City of West Linn
PRE-APPLICATION CONFERENCE MEETING
Notes
April 21, 2011

SUBJECT: Class I Design Review, Water Resource Area permit, and Class II Variance for moving ingress/egress points, moving walls, paving, and installing stormwater swale, at Dan Davis Recycling Center at 4001 Willamette Falls Drive. Variance is for curb cut width.

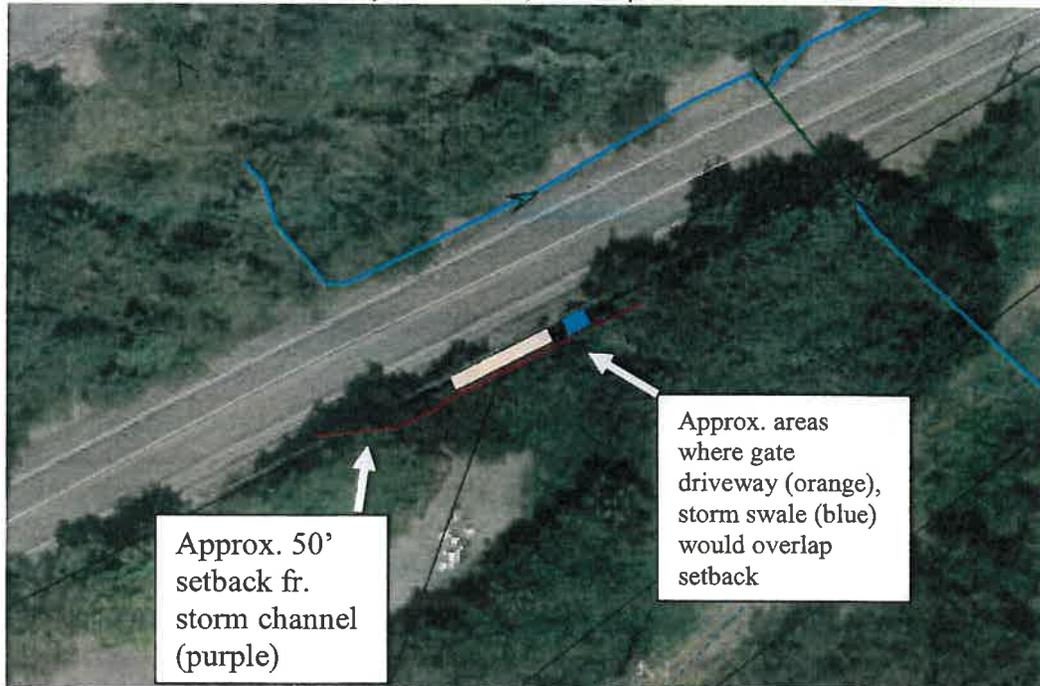
There is a storm channel across Willamette Falls Drive that is covered by the provisions of Chapter 32, per 32.020(C), as it is an open channel on the Surface Water Management Plan that is a roadside swale in a non-residential area. Therefore any development proposed within 50 feet of this channel requires the Water Resource Area permit, if the development is proposed where no paving or structures exist currently. Per both City GIS (insert below) and staff measurements, the only development proposed that would overlap with this 50 foot setback where there is not already development is in the northeast corner of the site. This overlap occurs where areas that currently have trees and vegetation would become developed with the north ends of the stormwater treatment swale and the driveway serving the new entrance gate. See these approximate overlap areas on the aerial photo insert below.

In the approval criteria for the Water Resource Area permit, 32.050(F) allows driveways to be built in these transition area setbacks if no other practicable alternative exists, so the applicant should demonstrate that no practicable alternative exists, or not propose

Also in the approval criteria for the Water Resource Area permit 32.050(M) allows stormwater treatment facilities to encroach up to 25 feet into the transition area setback as long as an equal sized area is added to the transition area on site. The proposed swale would definitely encroach less than 25 feet into the setback, so this should be fine as long as an undeveloped area on site that will remain undeveloped is added to the transition area to make up for this loss. For example if 100 square feet within the transition area are developed into part of the swale, areas east of the swale but further than 50 feet from the channel (contiguous to the current 50 foot setback) can be considered "added" to the transition area and preserved in an easement or via dedication to the City. Like the driveway, the storm swale could be proposed only in areas that are not in the Water Resource Area transition area. If both these changes are made to the proposal the Water Resource Area permit would not be needed. As the applicant discussed at the conference, the swale will be able to be adjusted to be out of the setback but the driveway will not be, so the permit will still be needed.
